TO	Jo Young	FROM	Parviz Namjou
	Stevenson Aggregates Ltd	DATE	12 August 2025
RE	Drury Quarry – Sutton Block Expansion, Auckland Council Further Information Request on Groundwater

Below is additional information in response to the Auckland Council's further information request on the proposed Drury Quarry – Sutton Block Expansion application.

FIGURE
FIGURE S1: STREAM AUGMENTATION PROGRAMME FOR STREAM REACHES WHICH MAY SHOW BASEFLOW REDUCTION
PROJECT
PROPOSED SUTTON BLOCK EXPANSION – GROUNDWATER & SURFACE WATER EFFECTS ASSESSMENT

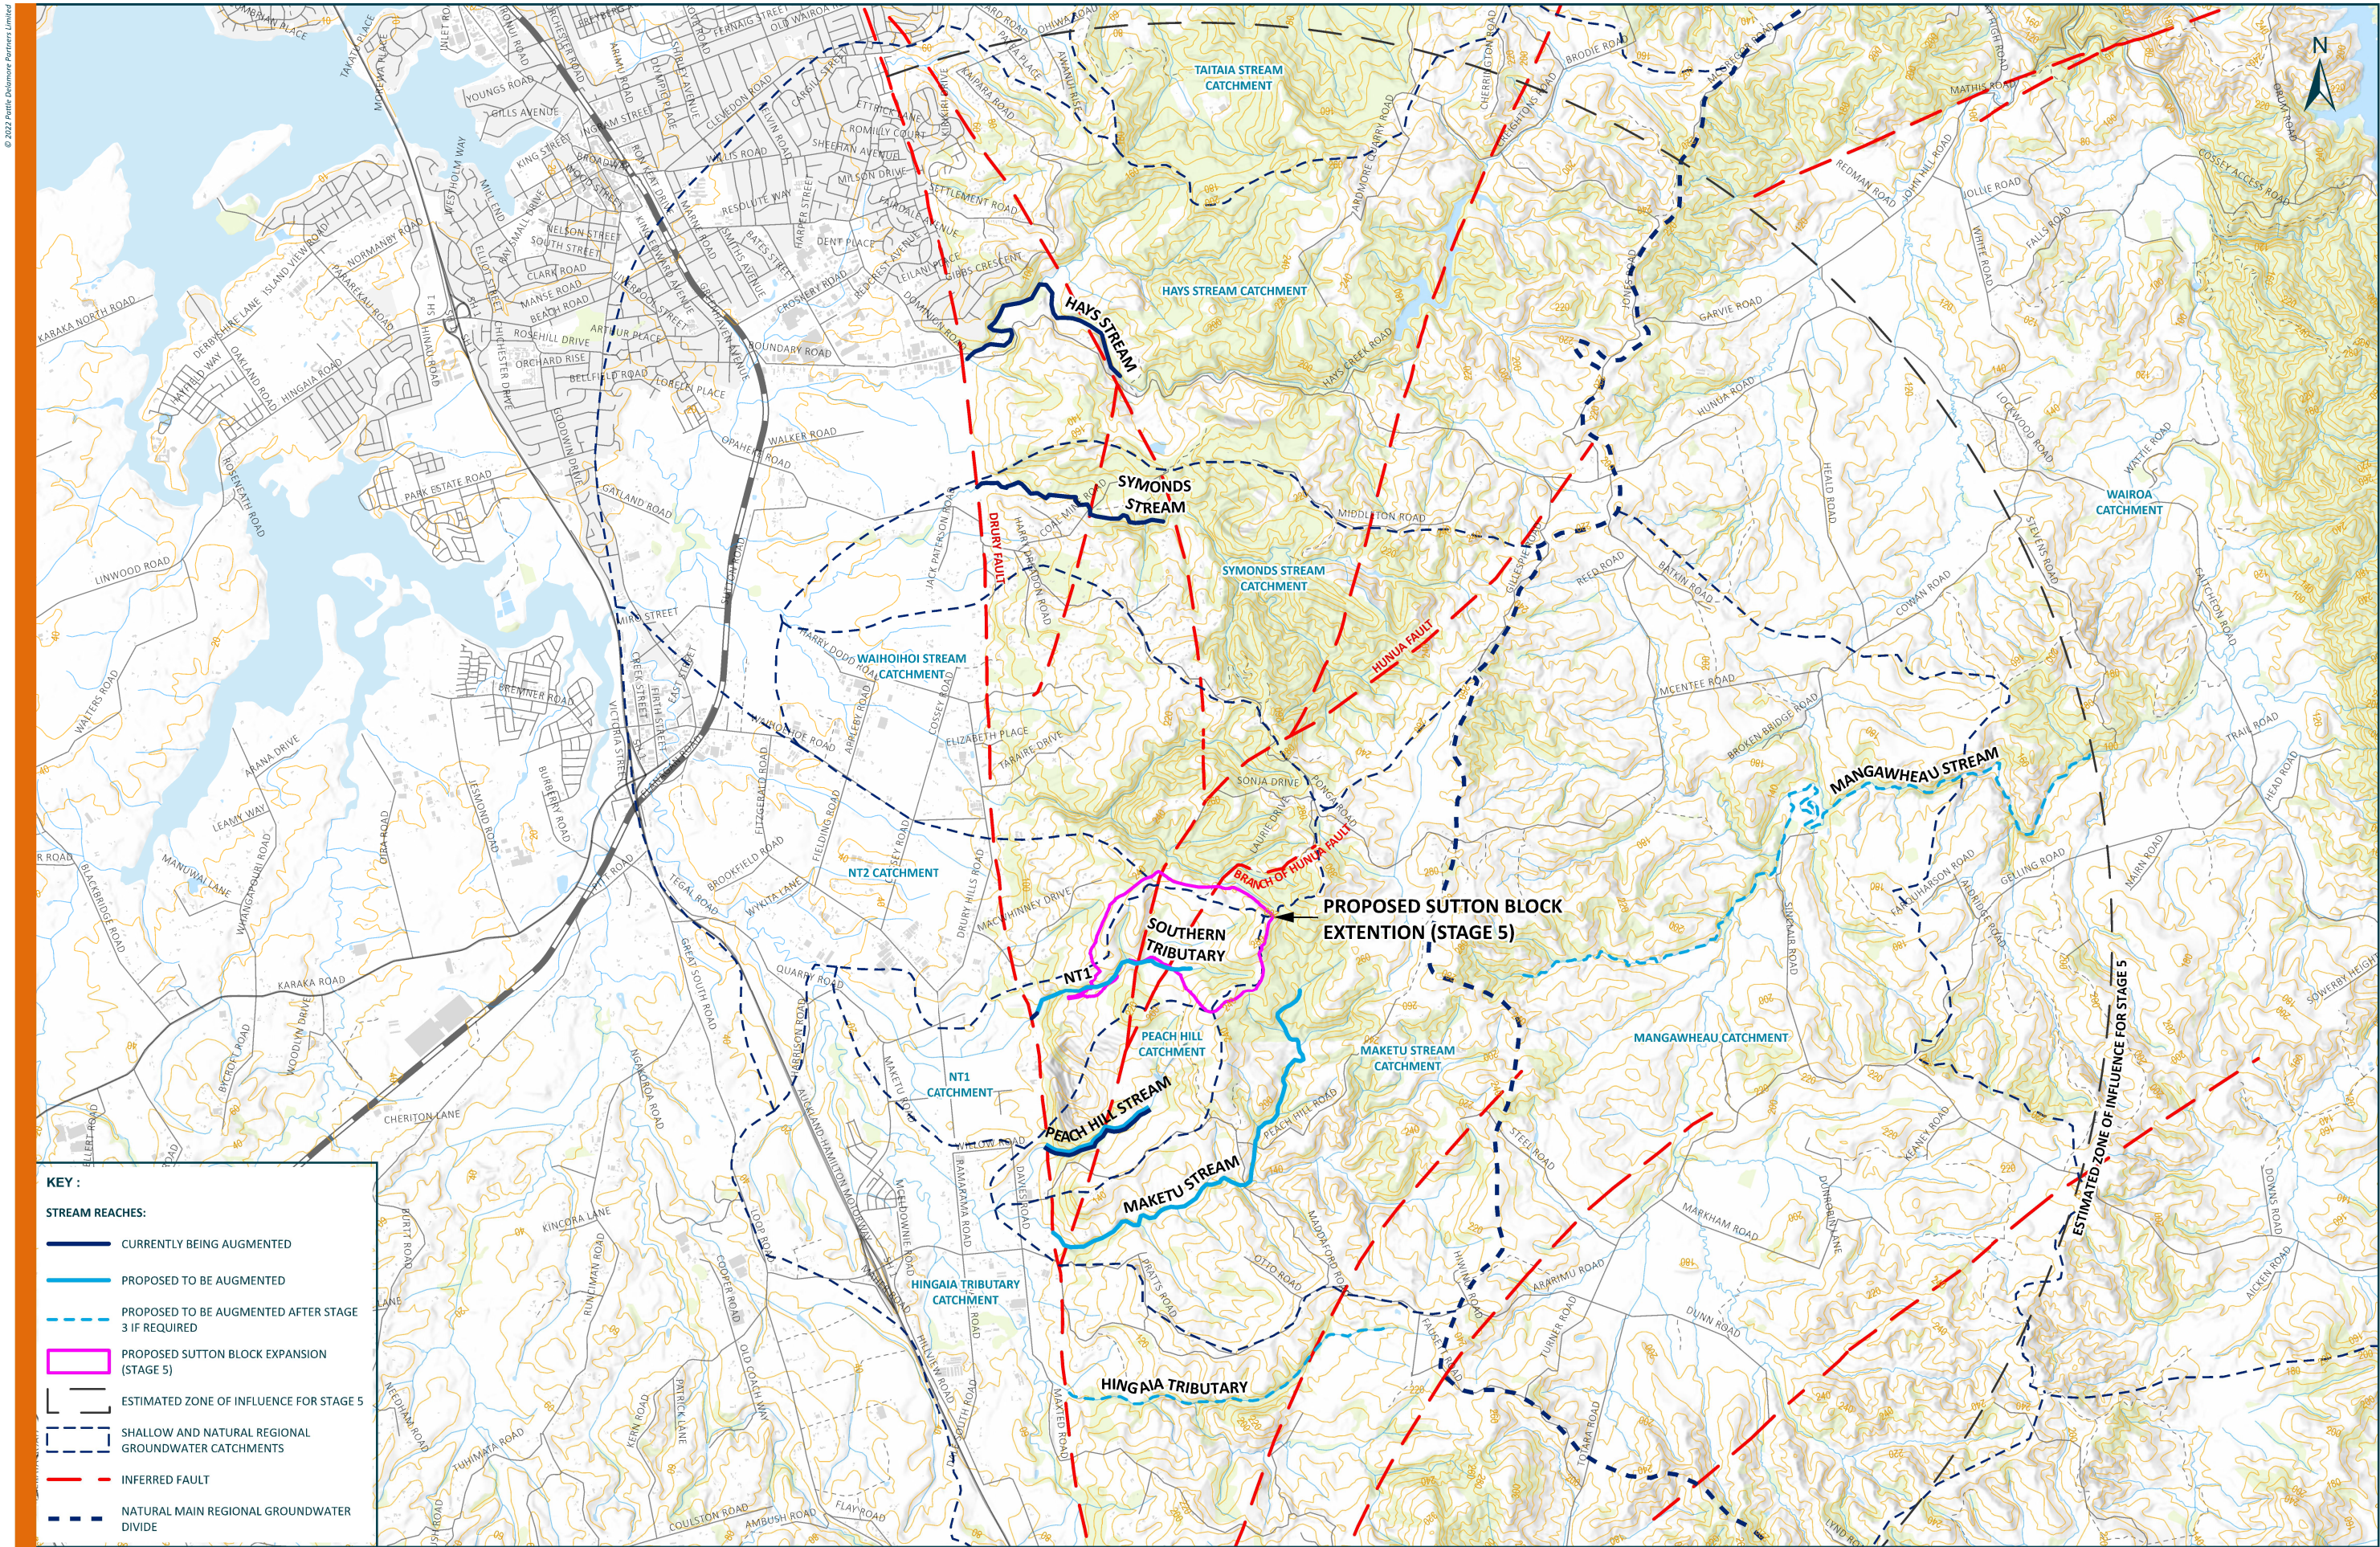
A plan showing all stream reaches expected to be subject to baseflow reduction associated with Stage 5 groundwater drawdowns, including cumulative effects from Drury and Hunua quarries. (Please show on plans at a suitable scale. The 1:70,000 scale drawings provided are very difficult to read.)

The augmentation plan and potential affected reaches of the streams within Stage 5 is shown in Figure S1 attached as Appendix A.
